**DEFENSE NUCLEAR FACILITIES
SAFETY BOARD**

RECOMMENDATION 2015-1 TO THE SECRETARY OF ENERGY
Emergency Preparedness and Response at the Pantex Plant
Pursuant to 42 U.S.C. § 2286a(b)(5)
Atomic Energy Act of 1954, as Amended

RECOMMENDATION 2015-1 TO THE SECRETARY OF ENERGY
Emergency Preparedness and Response at the Pantex Plant

Figure 5. NE or SNM Facility Fire EAL

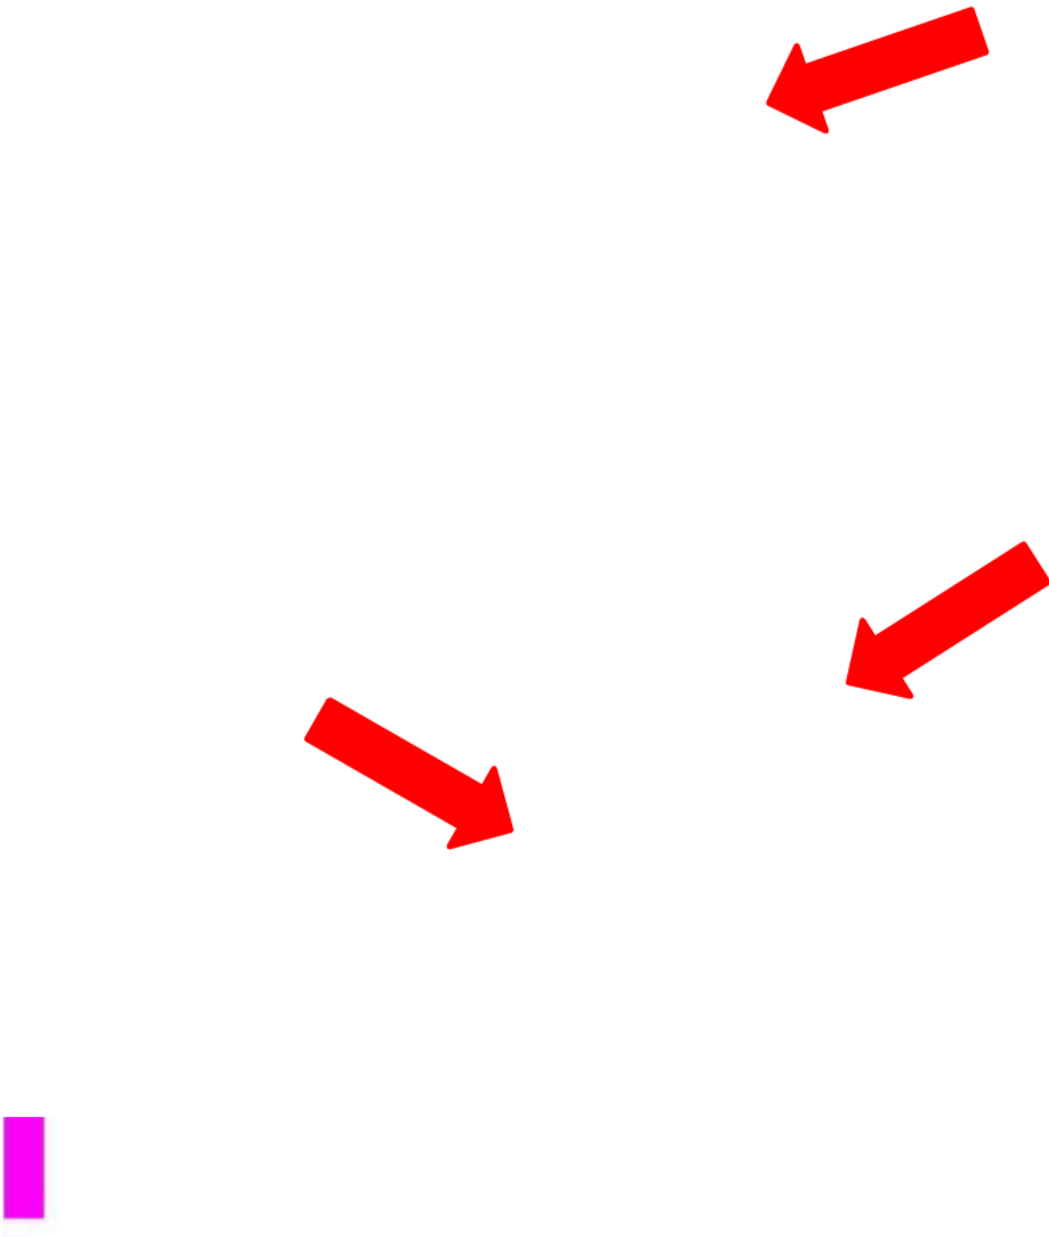
Similarly, note the reliance on personnel observations and inferences to assist the decision maker through appropriate classification of a fire in a nuclear explosive or special nuclear material facility [12].

Figure 7. Tritium Fire EAL

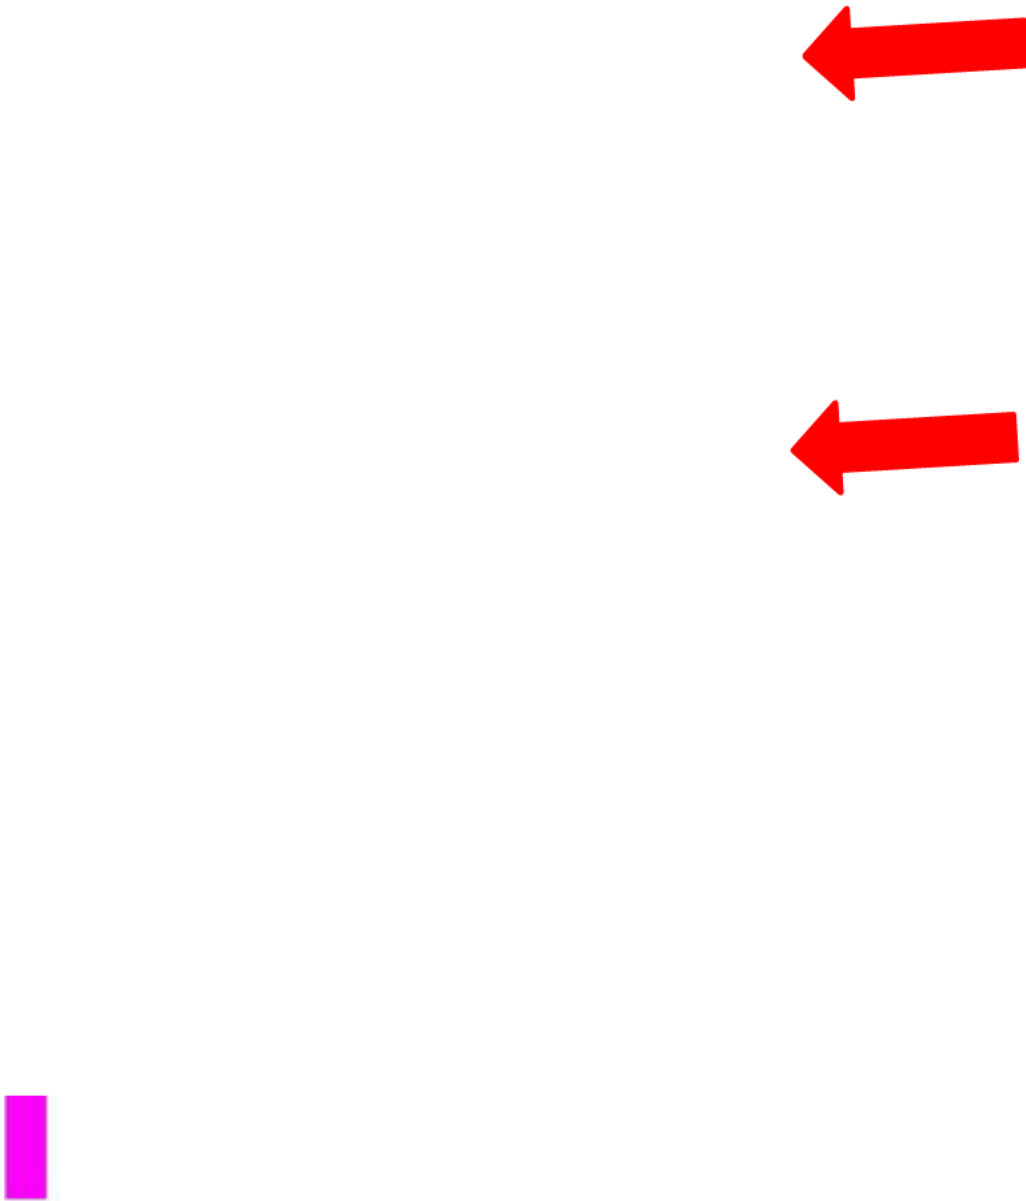
In the following example, it is not clear what a “Convincing Report” or combination of fire indicators is without further training or guidance on expectations for those who may report such events [12].
